**TYPE IV APPLICATION  
STAFF REPORT AND RECOMMENDATION**  
*September 8, 2015*

**FILE NUMBER:** ZC 15-02: Zone Change R-10 to R-6  
TP 15-03: 25-Lot Subdivision

**REQUEST:** The applicant is seeking approval for a Zone Change from “R-10” Single-Family Dwelling District to “R-6” Single-Family Dwelling District and a 25-Lot subdivision.

**LOCATION:** 19588 McCord Road, Oregon City, Oregon 97045  
Clackamas County 3-2E-07B -04100

Figure 3: Proposed Layout

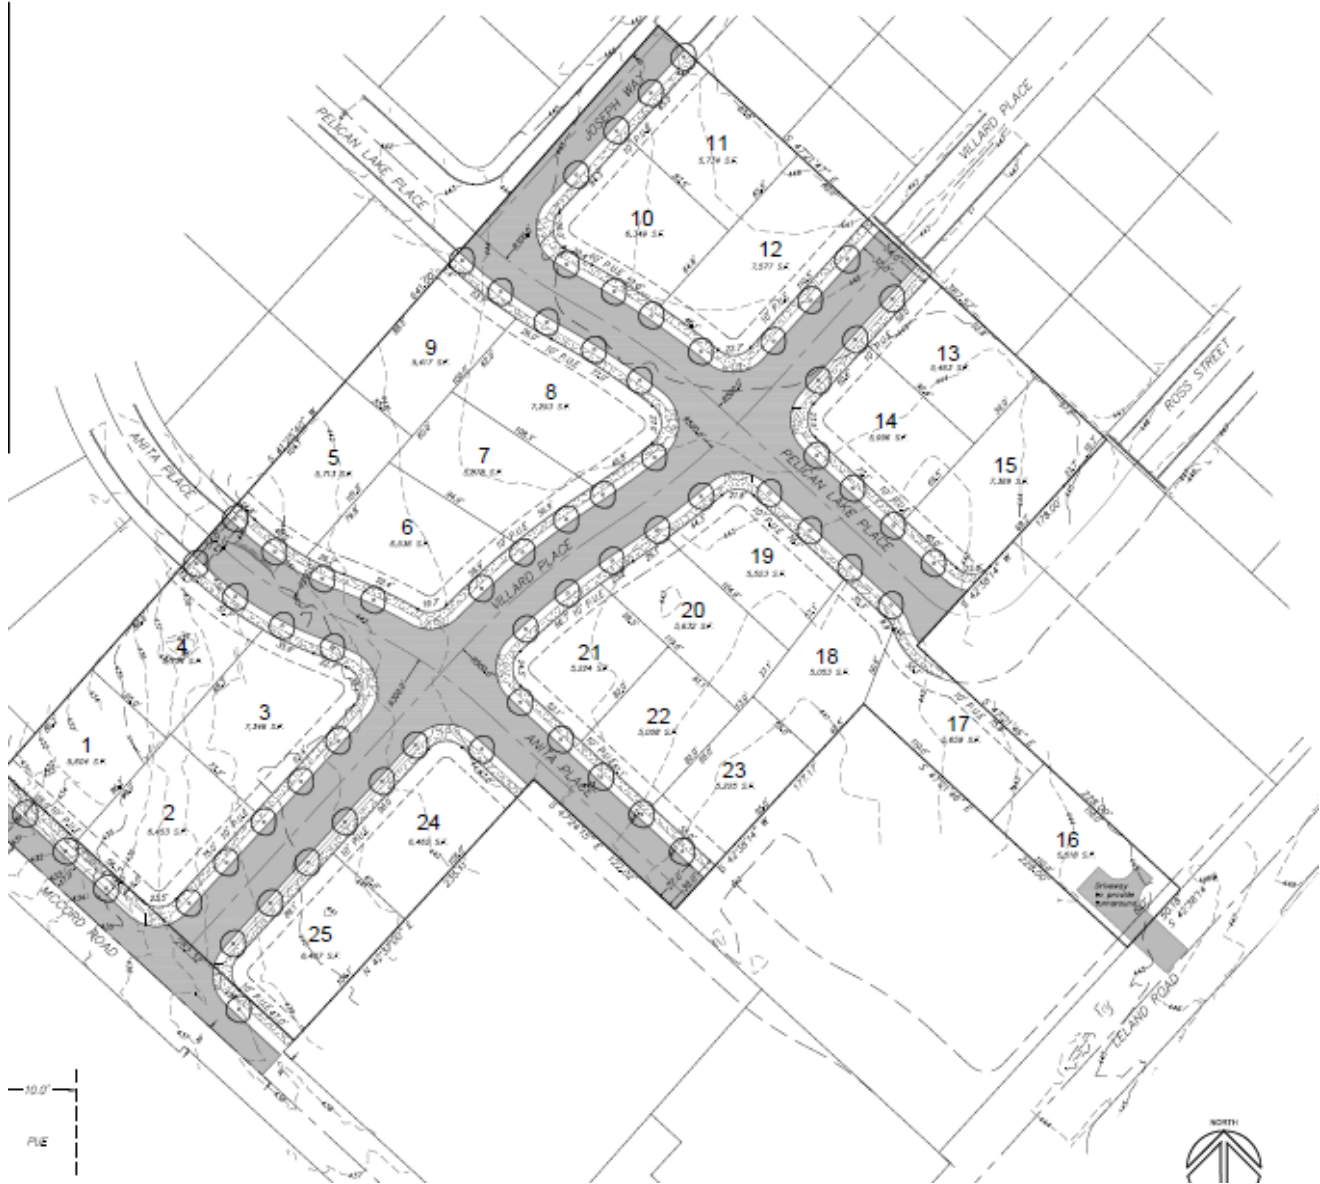
**Finding: Complies with Condition.** The applicant proposed providing water service from existing 8-inch ductile iron City water mains in the adjoining streets stubbed to the subject property (Anita Place, Pelican Lake Place, Joseph Way, and Villard Place). The applicant proposed these stubbed 8-inch water mains will be extended to service the proposed lots in the subdivision. The applicant further proposed to provide water service to Lot 16 (which fronts Leland Road) from an existing 8-inch Clackamas River Water District (CRW) water main installed in Leland Road. The applicant also proposed hot tapping an existing 8-inch CRW water line at the intersection of McCord Road and Villard Place. The CRW water mains in this area are in poor condition. They are scheduled to be abandoned in the future, and properties will be served by City water mains. Therefore, the proposed connections to CRW water mains will not be practical.

**Finding: Complies with Condition.** The applicant proposed extension of the existing 8-inch City sanitary sewer mains within Anita Place and at the intersection of Joseph Way and Pelican Lake Place to service the proposed lots in the subdivision. The applicant shall provide sanitary sewer laterals to all of the lots in the proposed development.

The applicant proposed a private sanitary service line for Lot 16 to run northwest across Lot 17 within a sanitary sewer easement and discharge within a proposed 8-inch City sanitary sewer main near the southern terminus of Pelican Lake Place. This does not meet the City's long-term plan for sanitary sewer service on Leland Road. The existing 8-inch Oregon City gravity sanitary sewer main and manhole near the intersection of Leland Road and Kalal Court shall be extended to the southwestern most boundary of

The applicant shall provide a 10-foot PUE along the entire frontage of Lot 17 (which will partially front Pelican Lake Place and the future Ross Street Extension). Currently, the applicant has proposed a 10-foot PUE along the eastern property line of Lot 17 and this is not required. See this section for discussion regarding a required water line easement across Lots 16 and 17.

6. The new water system will be designed with minimum 8-inch water mains throughout the site and will provide stubs with blow-offs for future extension with development of adjacent properties. The proposed 8-inch ductile iron water mains on Anita Place, Pelican Lake Place, Joseph Way, and Villard Place shall be connected to the adjacent, existing City water system on these streets per City Standards. (DS)

10. The applicant shall extend the existing 12-inch water main located at the intersection of Leland Road and Kalal Court to the southwestern most boundary of the proposed development's frontage along Leland Road to serve Lot 16 of the development. Extension of this 12-inch water main shall include all appurtenances, such as fire hydrants, valves, and fittings as needed for a complete water system. At time of construction plan submittal, alternative configurations may be evaluated for approval by the City Engineer. (DS)

17. The applicant shall provide sanitary sewer laterals to all of the lots in the proposed development. (DS)
18. The applicant shall install an 8-inch sanitary sewer main on Joseph Way as far as determined by the City Engineer necessary to provide sanitary sewer service to Lots 10 and 11. The proposed 8-inch sanitary sewer main shall be extended in its standard utility location per City standards. The sanitary sewer service connection for Lot 11 shall be made on the proposed 8-inch sanitary sewer main, and not directly to the proposed end-of-line manhole. (DS)

20. The applicant shall install an 8-inch sanitary sewer main on Villard Place as far as determined by the City Engineer necessary to the northeast to provide sanitary sewer service to Lot 13. The sanitary sewer service connection for Lot 13 shall be made on the proposed 8-inch sanitary sewer main, and not directly to the proposed end-of-line manhole. (DS)

21. The applicant shall extend the existing sanitary sewer system (manhole and main line) located at the intersection of Leland Road and Kalal Court to the southwestern most boundary of the proposed development's frontage along Leland Road to provide sanitary sewer service for Lot 16. The sanitary service lateral for Lot 16 shall be installed to run perpendicular to the extended 8-inch sanitary sewer main within Leland Road per City standards. The sanitary sewer service connection for Lot 16 shall be made on the proposed 8-inch sanitary sewer main, and not directly to the proposed end-of-line manhole. The applicant will not be required to extend the sanitary sewer main on Leland Road if they can demonstrate, to the satisfaction of the City Engineer, that all upstream, undeveloped properties that abut Leland Road can be served from other locations. If this can be adequately demonstrated, the sanitary sewer lateral for Lot 16 can be located within a private sewer easement across Lot 17 and discharge into the proposed sanitary sewer system on Pelican Lake Place. (DS)

22. Public storm sewer improvements shall be designed and constructed to collect and convey on-site and off-site storm drainage. The public storm water collection system shall be located in the public right-of-way, and shall consist of a minimum 12" mainlines, catch basins and manholes. This includes a temporary asphalt berm along the southern side of Anita Place to collect the run-off from the street. (DS)
